**Re: Engineering Geology Assessment-Addendum II
Lot 15, Ski Lake Estates No. 3
6640 East 1100 South
Huntsville, Utah
Job No. 145150**

The purpose of this letter is to respond to the second geology review comments⁵ provided by Simon Associates, LLC, third-party consultant, hired by Weber County to review the referenced geology assessment letter.

PHOTO EXHIBIT 1

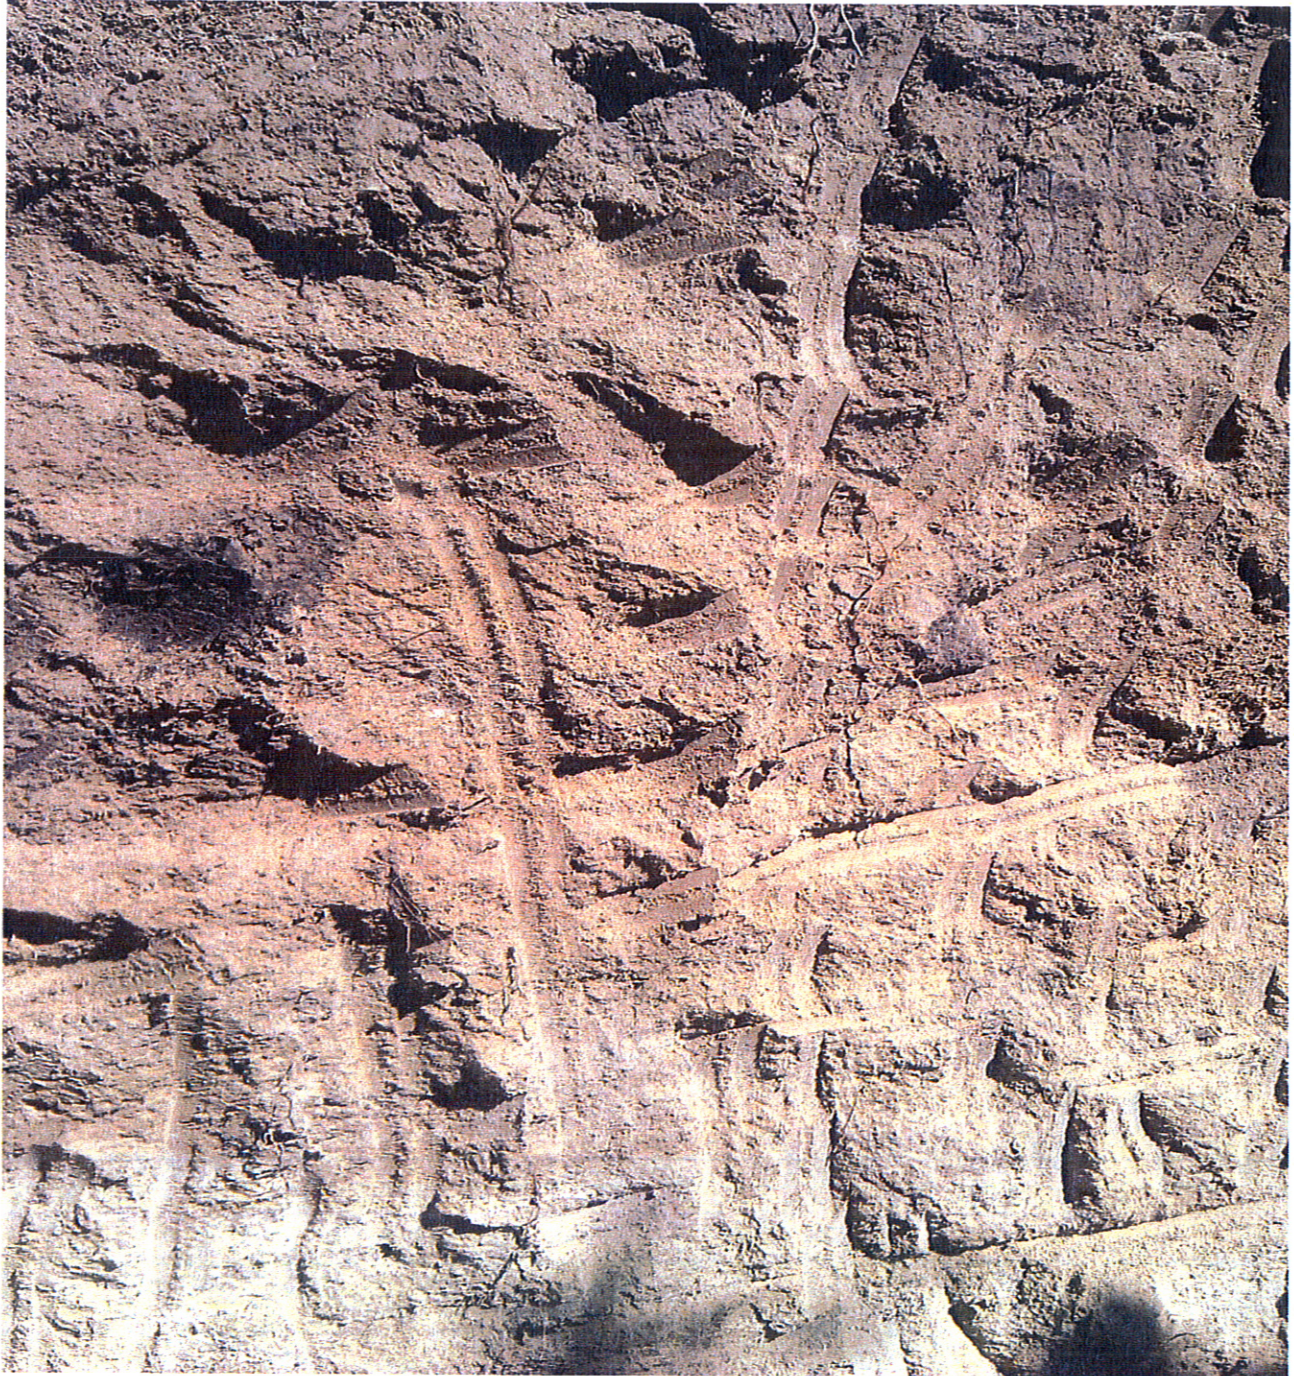
Review Comment 4 states: *"Item 3 of the August 6, 2015, SA review letter recommended Weber County request annotated photographs of TP-5 and the extension of TP-3 excavated on 6-22-2015. The photographs submitted with the August 14, 2015, EEl addendum were not annotated. SA recommends Weber County request annotated photographs of TP-5 and extension of TP-3 excavated on 6-22-15."*

Test pit TP-3 and its extension was photographed as shown in Exhibit 1 through 3, Appendix A. Photographs of TP-5 were not taken, and this test pit was backfilled.
